Re: Fairland Golf Community (Preliminary Plan #1-05020 and Site  
Plan # 8-05006)

This is to update our comments on the referenced preliminary/site plan as it relates to the future elementary school site on the proposed plan.

FUTURE SCHOOL SITE

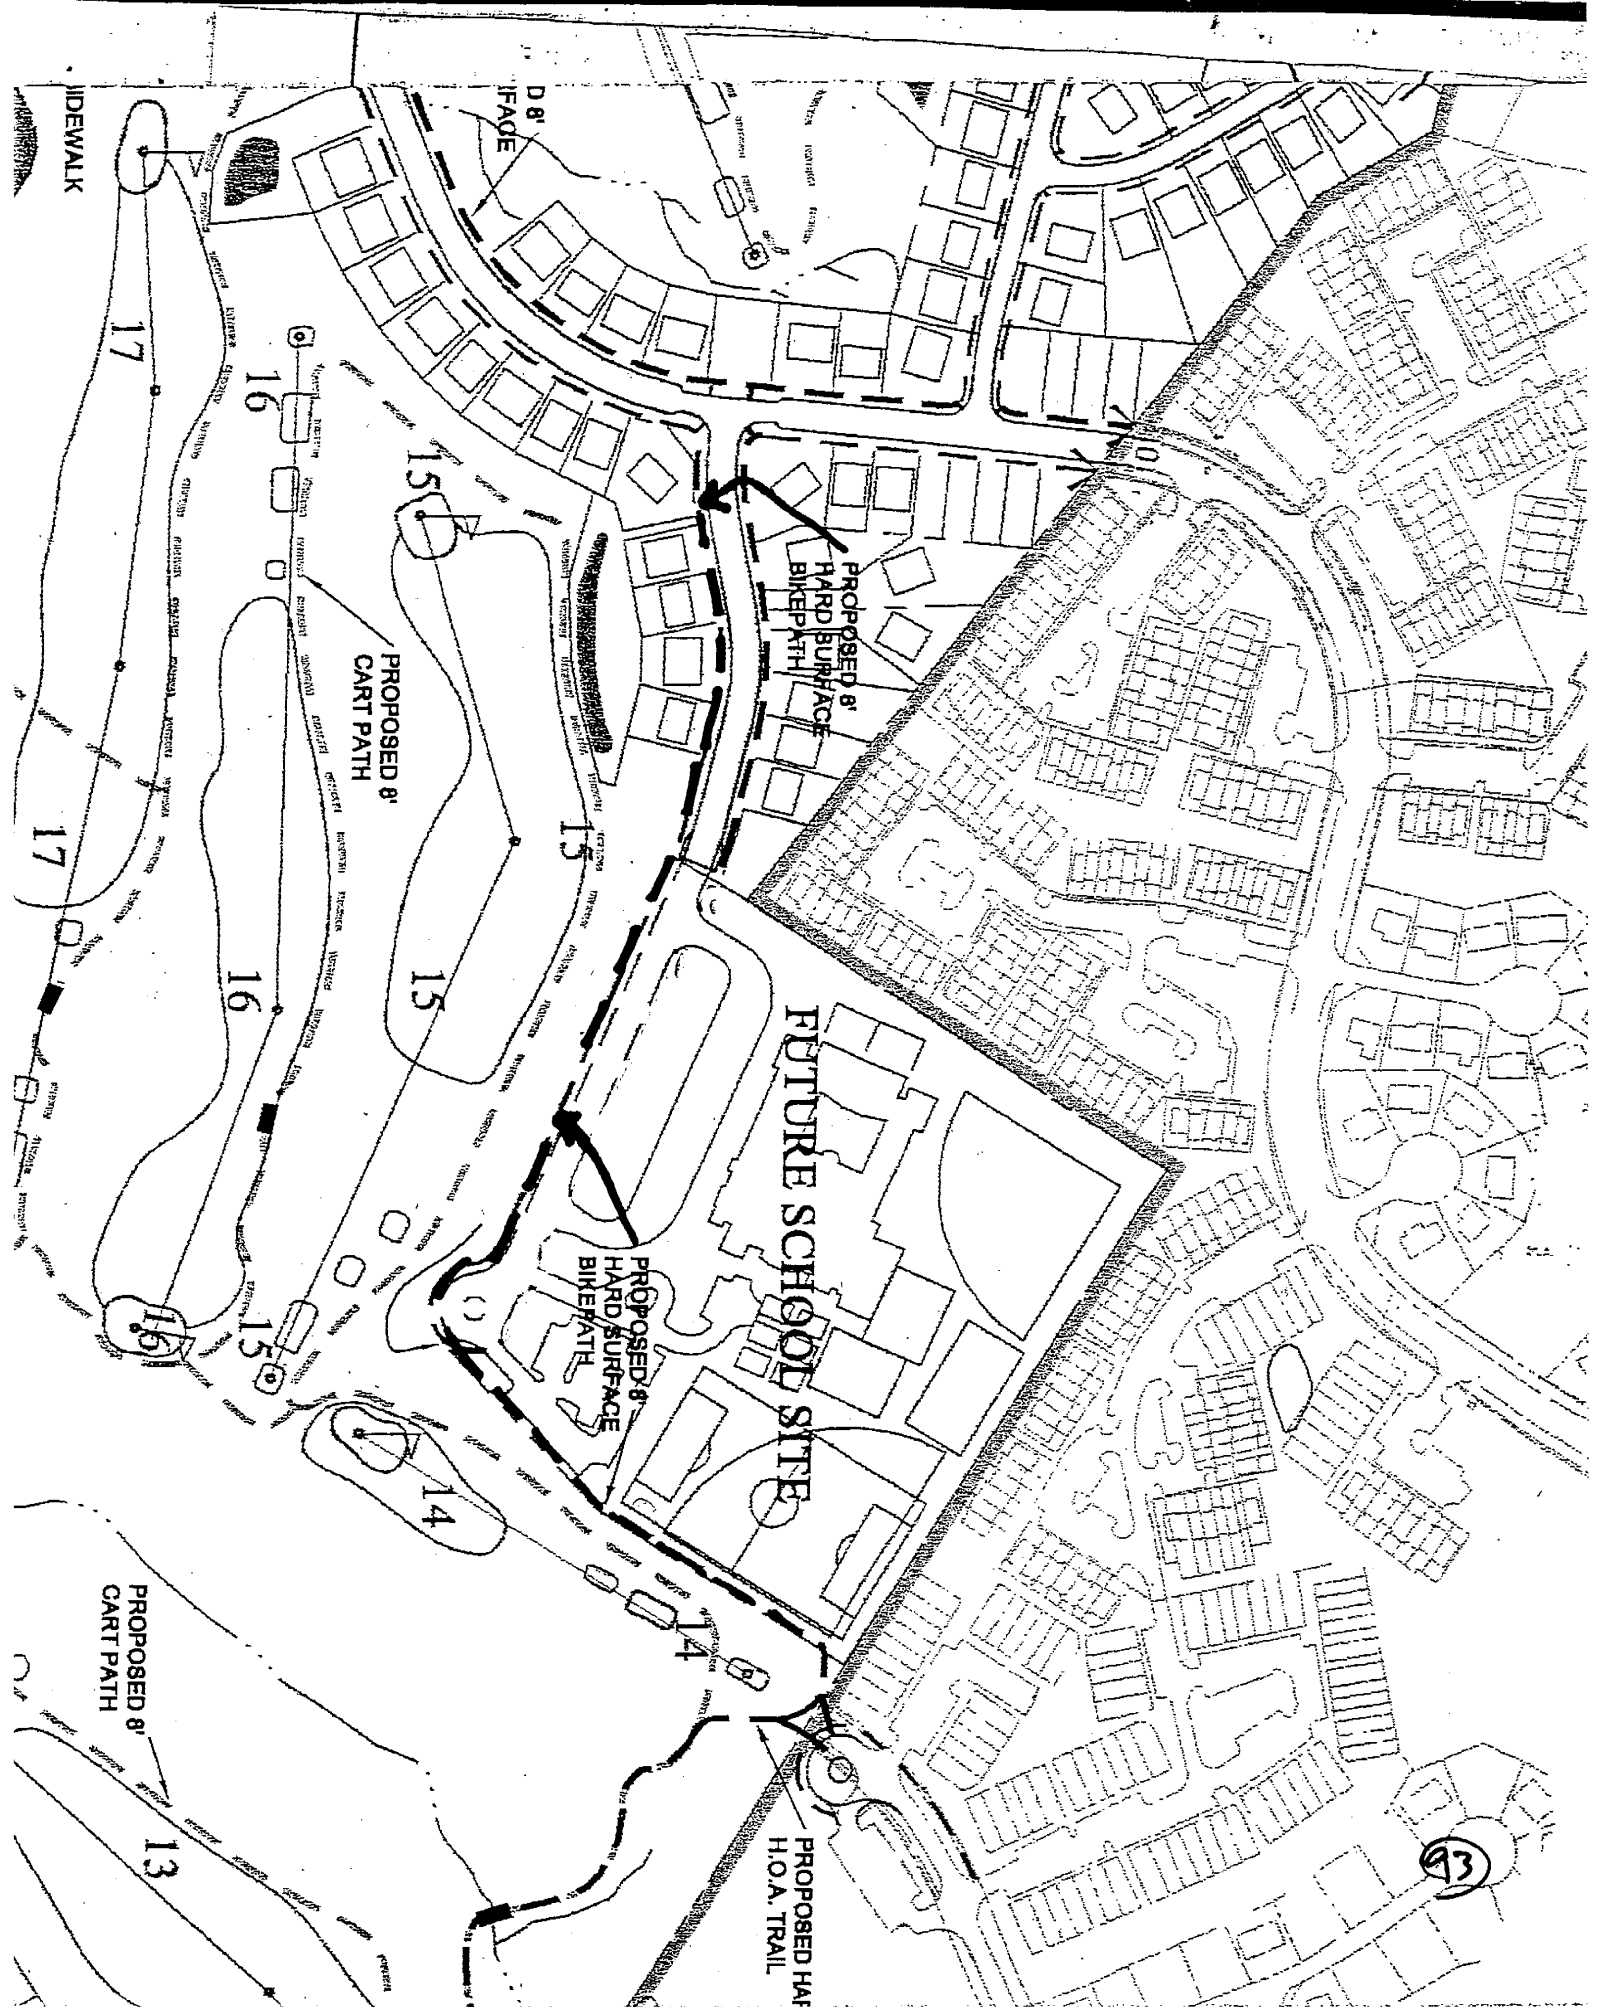
- Prior to conveyance of the school site to the Board of Education, dedicate and record plats for (1) the future school site and (2) a 70-foot wide primary subdivision street along the frontage of the school, terminating in a cul-de-sac.
- Construct a bike path in the future right-of-way in the alignment as shown on the enclosed drawing. The path should continue parallel to the 14<sup>th</sup> fairway and remain off of the future school property and connect to Saddle Creek Drive. A drawing that shows the preferred bike path alignment is enclosed.
- Provide adequate buffering between the golf course and the school site to include the installation and future maintenance of mesh fencing by the golf course operator to prevent golf balls from landing on the school site.
